## Change Order Request

**Williamson County Expo Center**

**Flintco, LLC****Project # 15035****Change Order Request: 013****Date: 6/29/2016**

PCO #: 042	6/29/2016	Additional Scopes Via RFI ASI and Coordination			New
Category	Reason	Reference	COR Number	PCCO Number	
Change Order	Contingency				
Notes	Revenue Code

PARTIAL ROOF  
FRAMING PLAN  
PRE-FUNCTION  
AREA

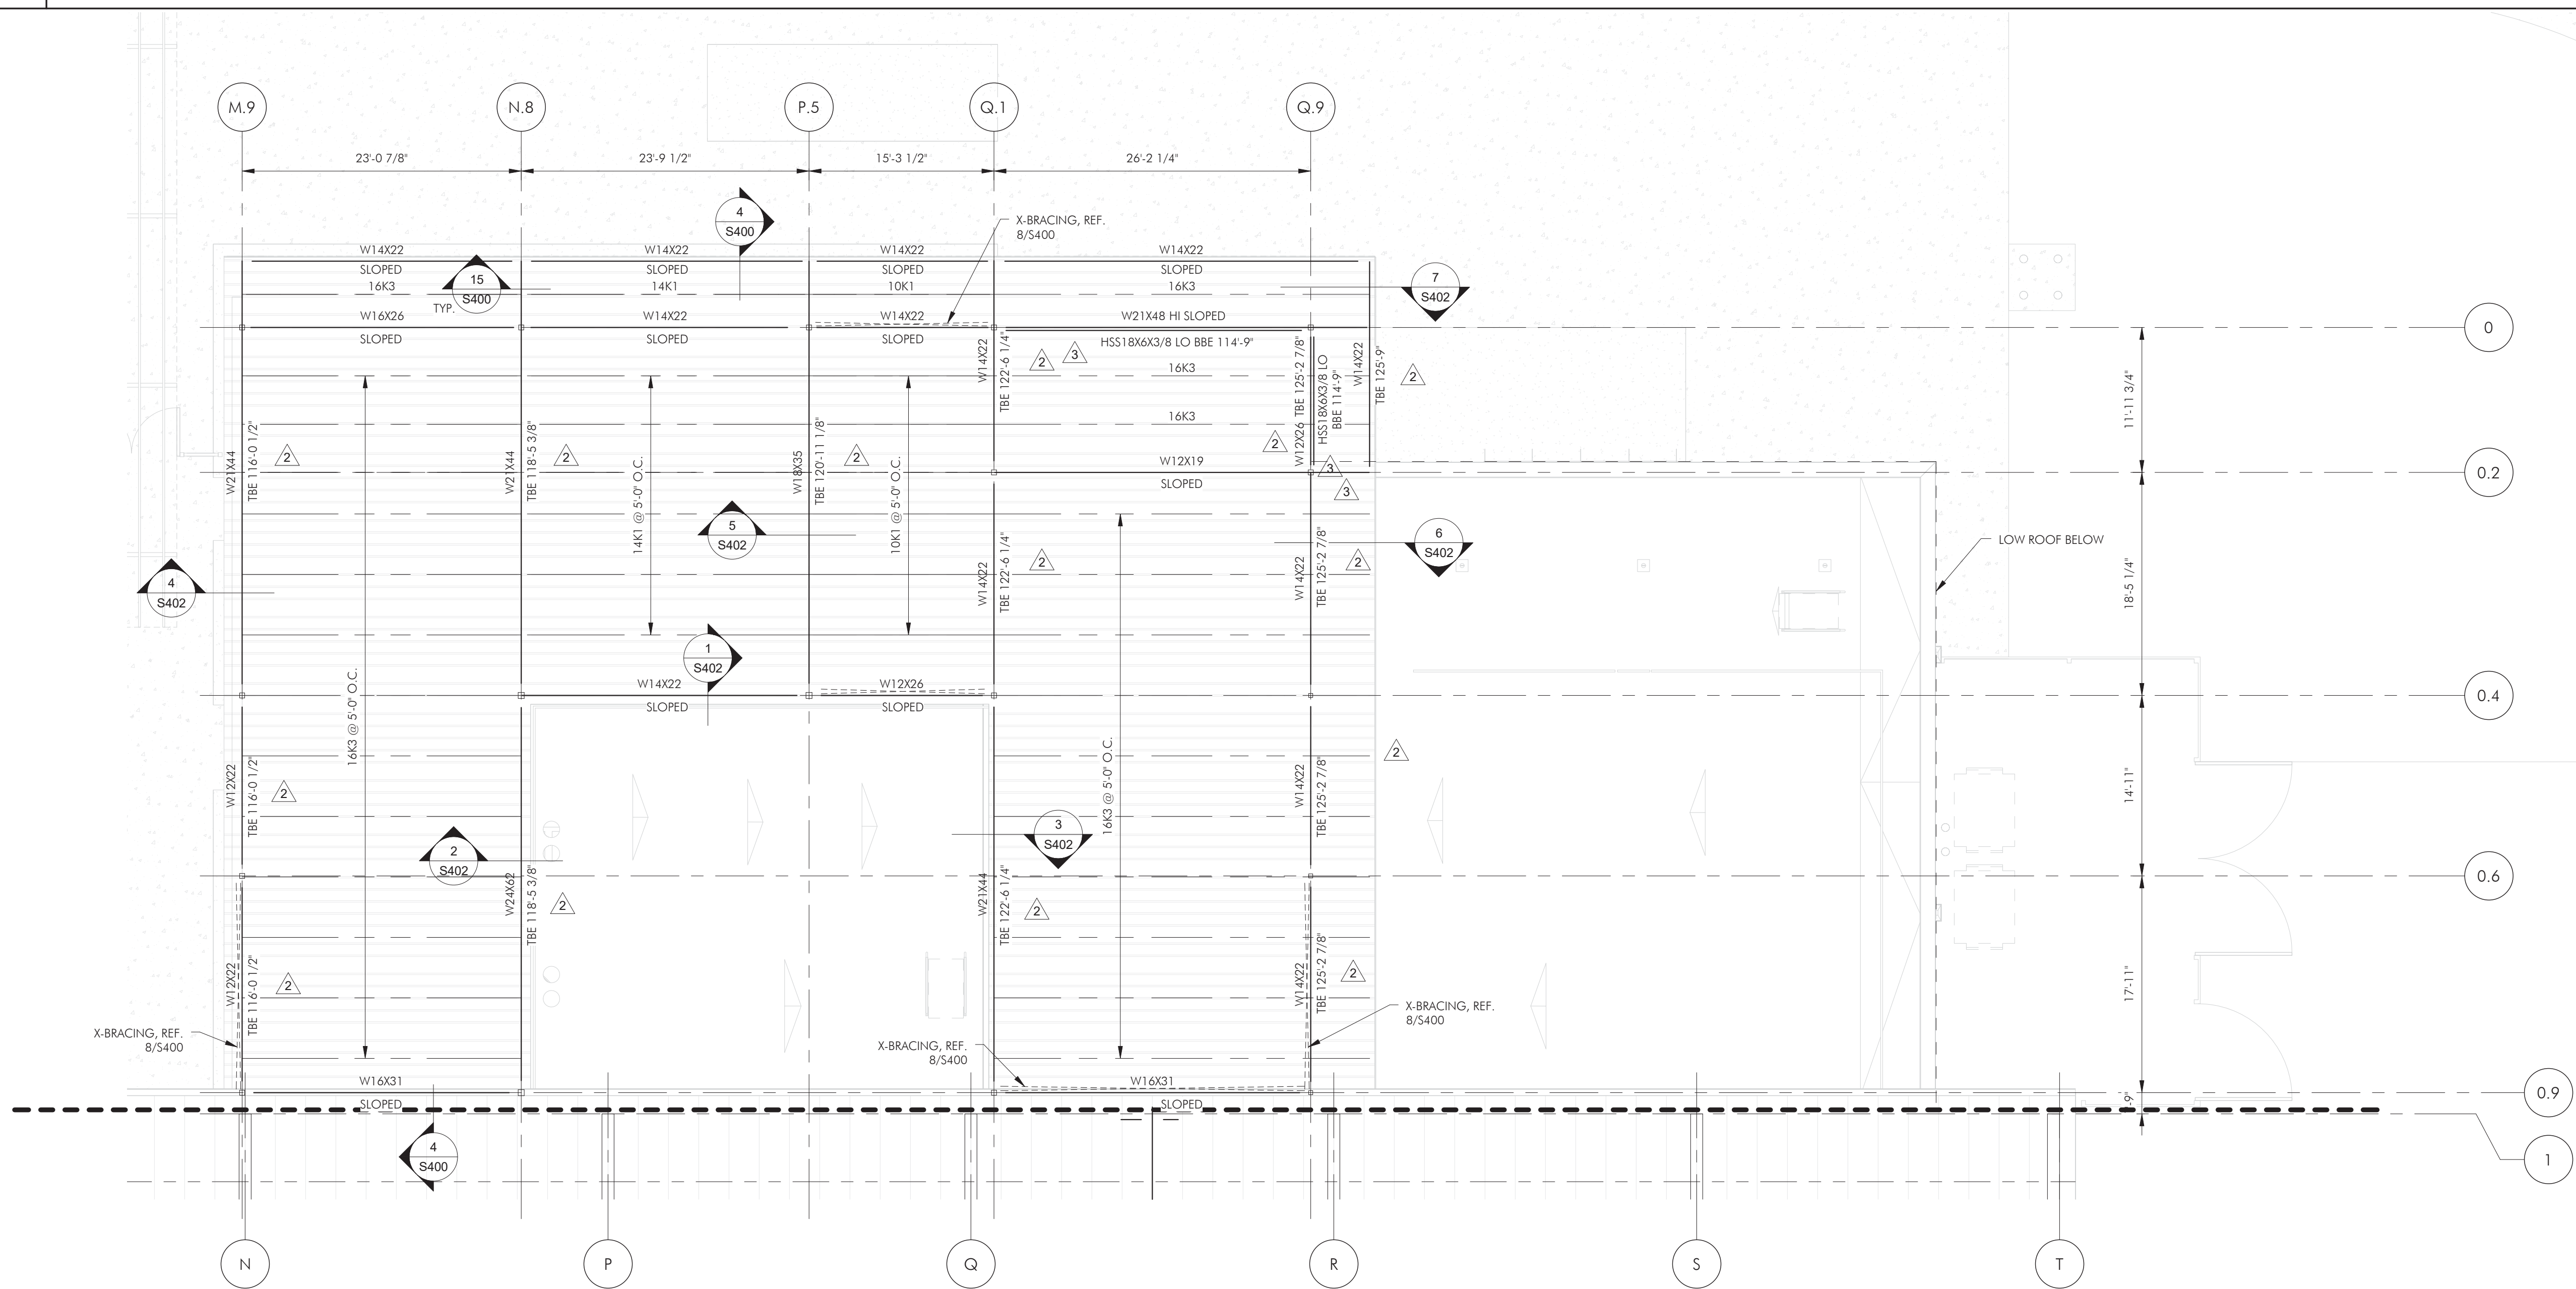
Relocate X-Bracing as noted on attached Sheet S201R4.
